APPEAL SUMMARY

Appeal ID: 24410	Project Address: 624 NW 18th Ave
Hearing Date: 11/25/20	Appellant Name: Jason Fifield
Case No.: B-015	Appellant Phone: 503-752-8099
Appeal Type: Building	Plans Examiner/Inspector: Guy Altman
Project Type: commercial	Stories: 6 Occupancy: R-2, B, S-2 Construction Type: I-A III-B
Building/Business Name:	Fire Sprinklers: Yes - Throughout
Appeal Involves: Erection of a new structure,Reconsideration of appeal	LUR or Permit Application No.: 20-211615-CO
	Proposed use: Multi-family dwelling

This project is the Susan Emmons North Building, which is new construction consisting of (5) stories of Type III-B construction over (1) story of Type I-A construction. The project will be provided with a fire sprinkler system per NFPA 13. The project will provide a total of (98) affordable dwelling units and associated amenity, service, and administration spaces. (2) interior exit stairways are provided, with Stair 01 exiting through an exit passageway at Level 1. The egress from Stair 02 is at Level 2 through the lobby at the level of exit discharge. The proposed design complies with all requirements of 1028.1 Exception 1.

FIRE LIFE SAFETY PLAN - LEVEL 2

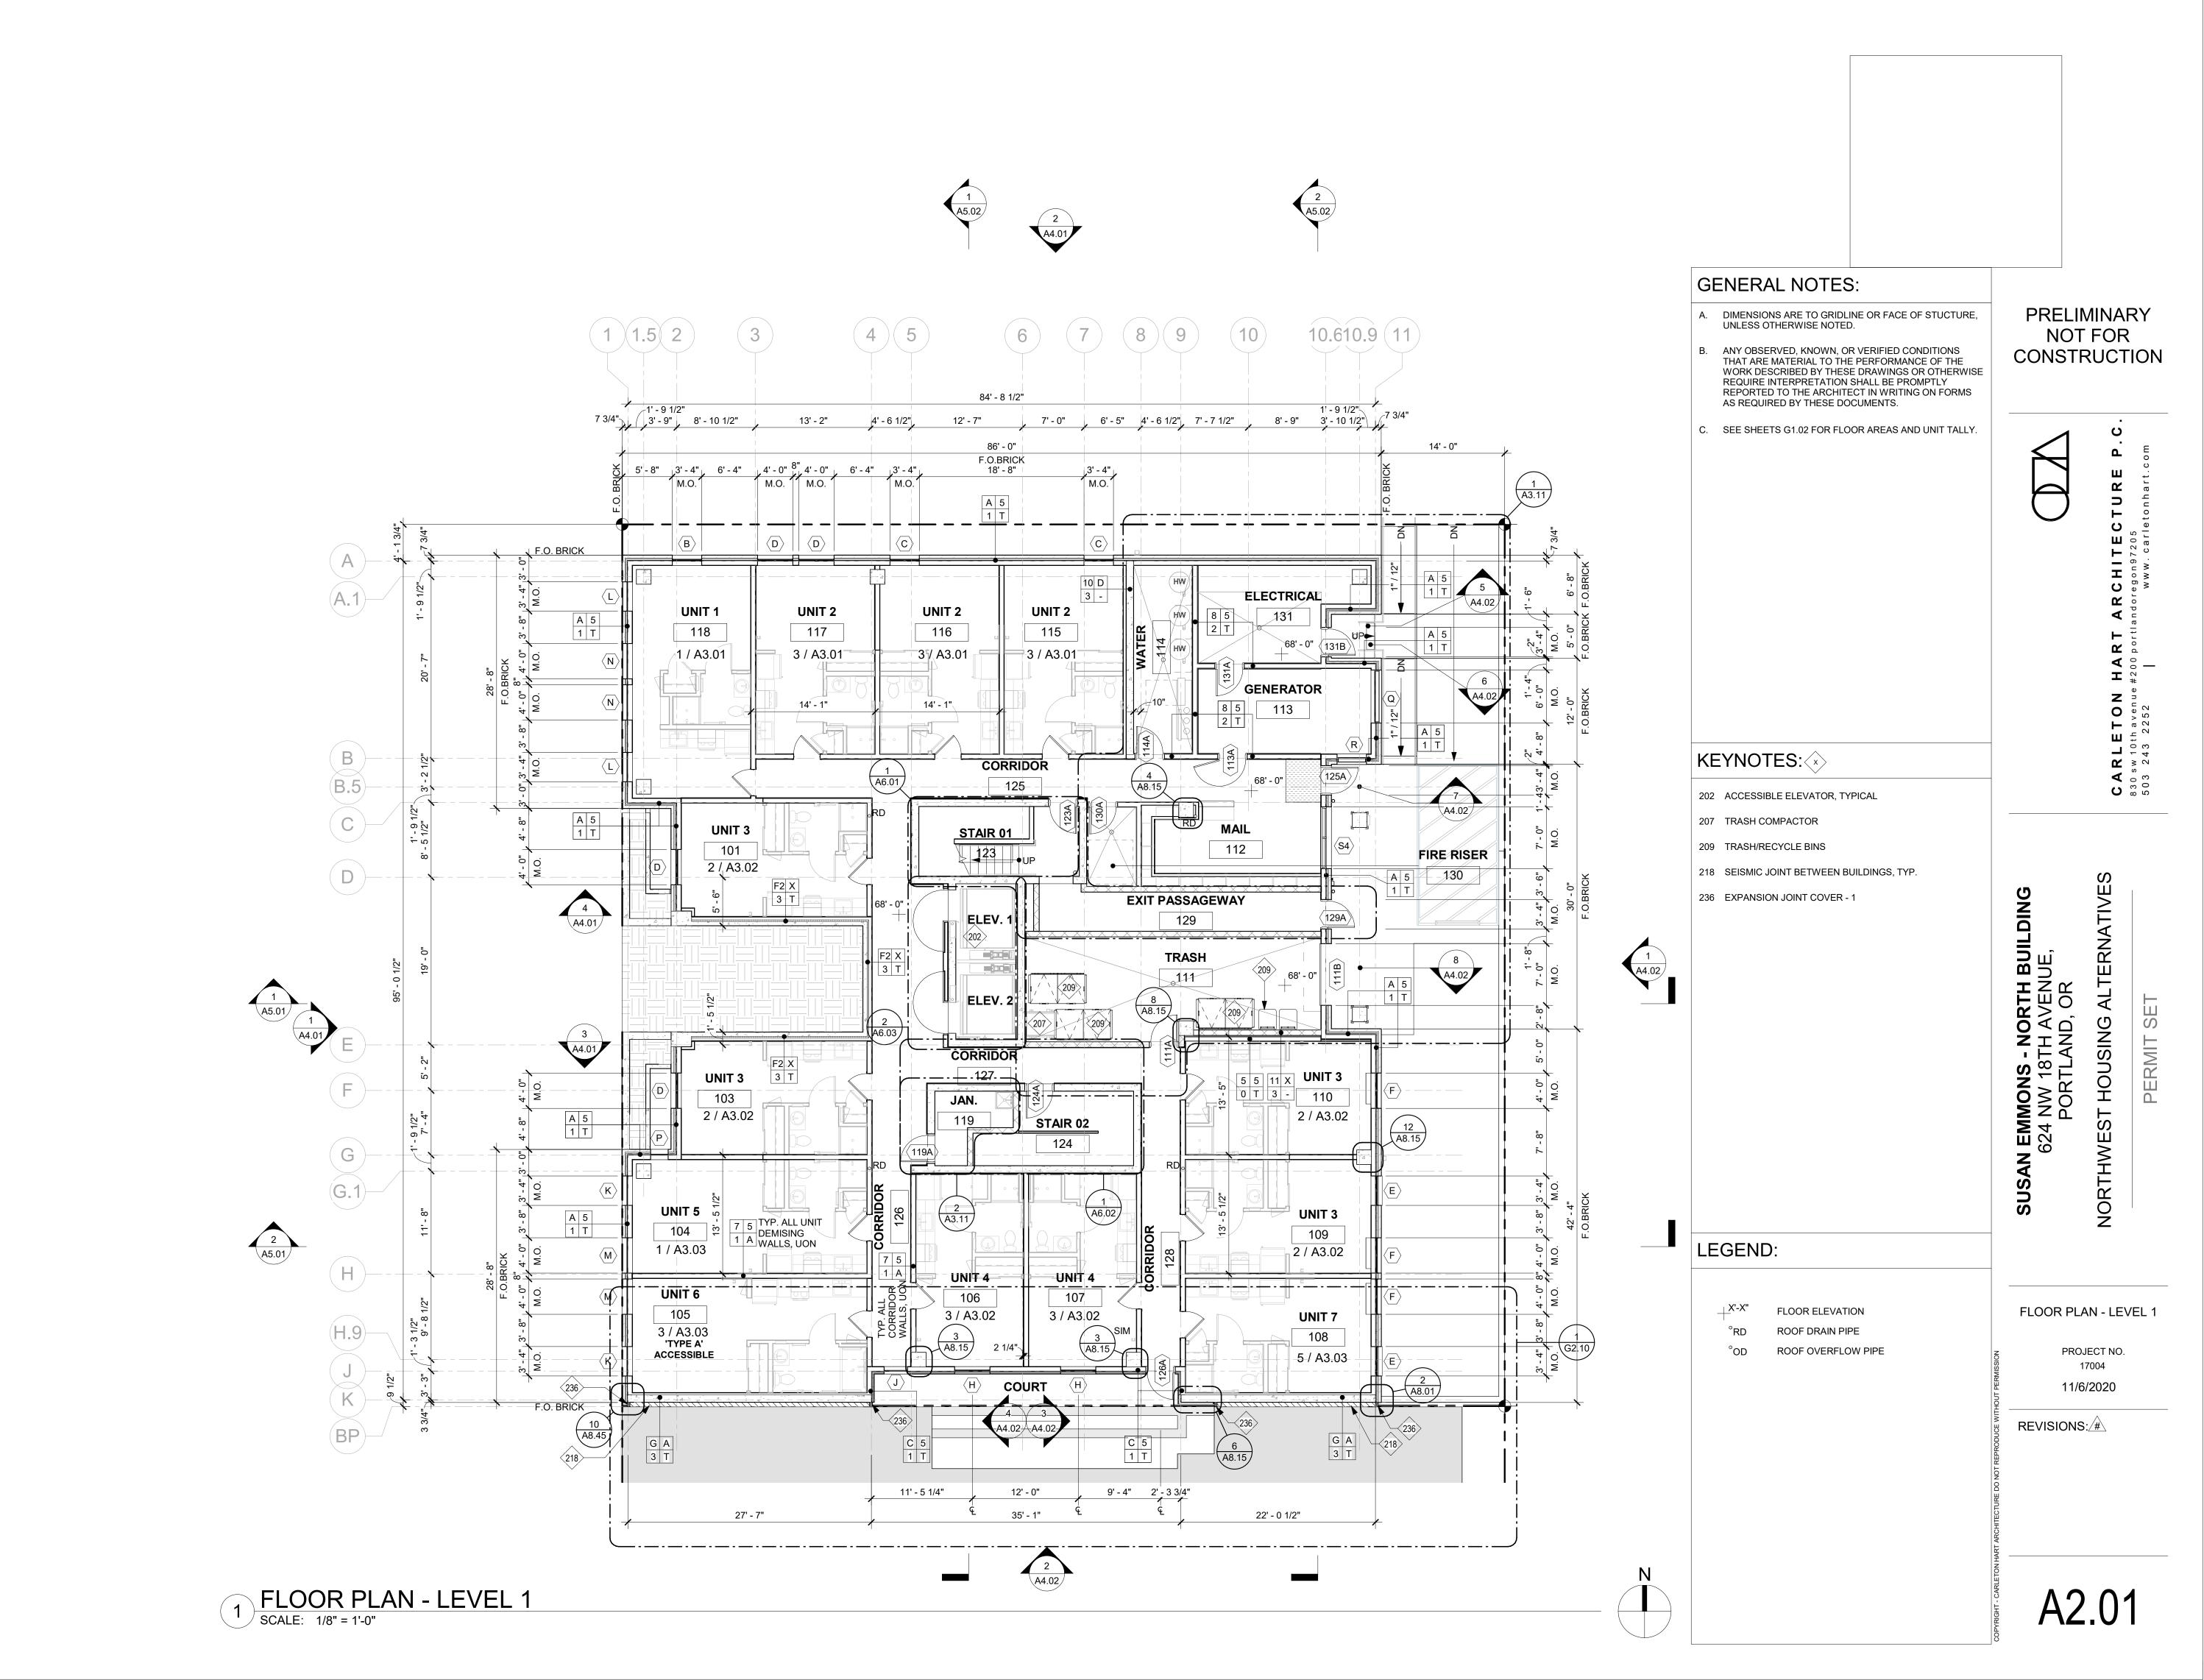
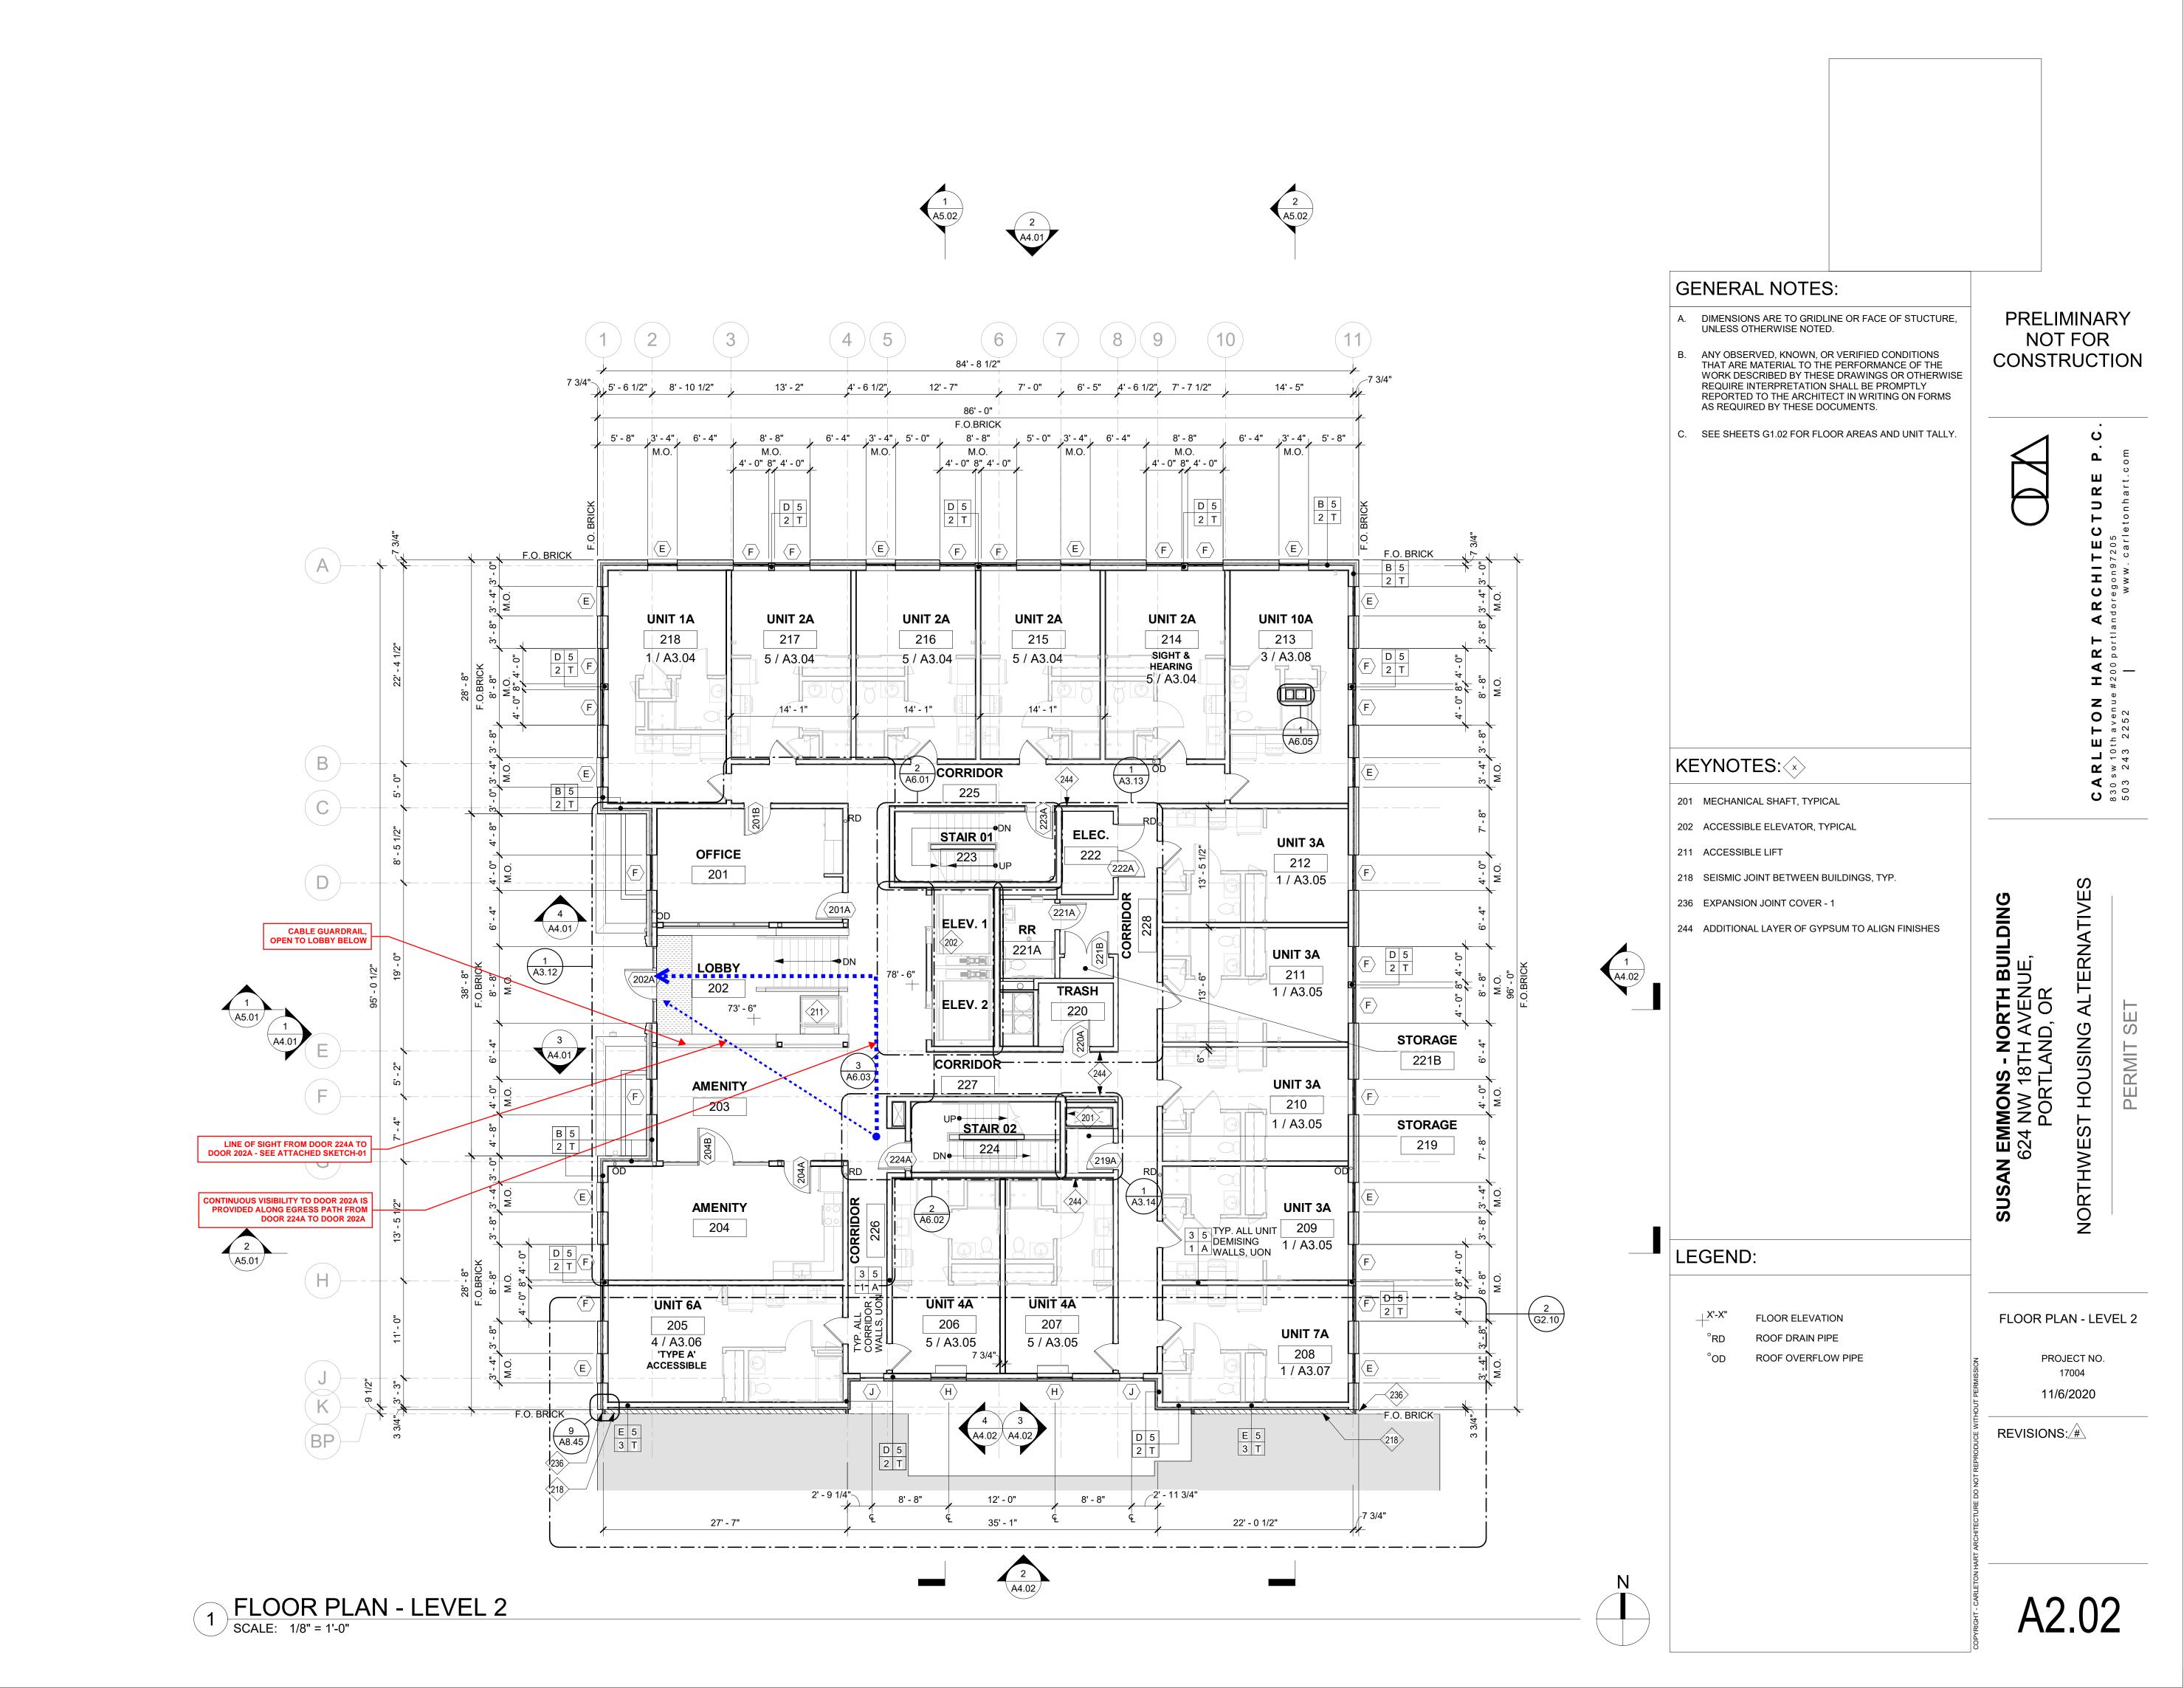
The design team proposes the path of egress from Stair 02 to the exit discharge at door 202A as shown in the attached drawings.

Visibility of the exit discharge at door 202A is provided for the entire egress path from Stair 02 to the exit discharge at door 202A. Amenity 203 is open to Lobby 202 with only a cable guardrail between spaces. This allows for visibility of door 202A upon passage through door 224A, and maintains visibility for the duration of travel to door 202A. Exit signs are provided as shown in the attached documents to further identify the egress path. Travel from Stair 02 to Lobby 202 is provided via an accessible stair and via a wheelchair lift. The egress path does not pass through a space that will create an obstruction in the path of travel.

Level 2 is provided with (2) exits: (1) exit is provided at Stair 01 and (1) exit is provided at door 202A, which is the exit discharge. The corridors at Level 2 are open to Amenity 203 and Lobby 202. The fire rating of the corridor extends to include Amenity 203 and Lobby 202, which is acceptable per 1020.6 Exception 1. Amenity 203 and Lobby 202 are separated from adjacent spaces with minimum 1 hour rated fire partitions. The floor below Level 2 is a 3 hour rated posttensioned concrete slab or slab on grade, and the floor / ceiling assembly between Level 2 and Level 3 is a 1 hour rated assembly.

Amenity 204 contains a shared kitchen, which is provided with residential appliances. The fire rating of the corridor wall extends to include the wall separating Amenity 203 and Amenity 204. The wall that separates Amenity 203 and Amenity 204 is a 1-hour fire partition. The door and relites in this wall are provided with 45-minute glazing and 45-minute assemblies. Door 204A is provided with magnetic hold opens that close upon activation of the fire alarm.

> The exit discharge is located at grade and is 5'-0" below the discharge from Stair 02, which occurs at Level 2. Access from Stair 02 to the exit discharge is provided via accessible stairs and a wheelchair lift. This necessitates the egress path from Stair 02 to the exit discharge at door 202A as shown in the attached drawings.

This arrangement provides equivalent health, accessibility, and life safety because a free and unobstructed path is provided from the interior exit stairway to the exit discharge and visibility of the exit discharge is maintained for the entire path of egress from the interior exit stairway to the exit discharge. The path of egress is provided within the corridor and entry lobby of the building, which do not pose a risk of being obstructed or of limiting the visibility of the exit discharge. See the attached drawings for more information.

Because the fire rating requirements of corridors are extended to include Lobby 202 and Amenity 203, these spaces are not intervening rooms and it is acceptable for them to be open to the corridor per 1020.6 Exception 1.

The extension of the fire rating of the corridor provides a fire rated separation between Amenity 203 and Amenity 204, which ensures a fire rated separation between the shared kitchen and the egress path. The utilization of a fire partition and fire rated doors and relites provides protection against the risk of fire and smoke from impacting the means of egress by protecting the boundary between Amenity 204 and Amenity 203.

Stair 2 discharge not at level of building exit discharge: Denied. Proposal does not provide equivalent Life Safety protection.
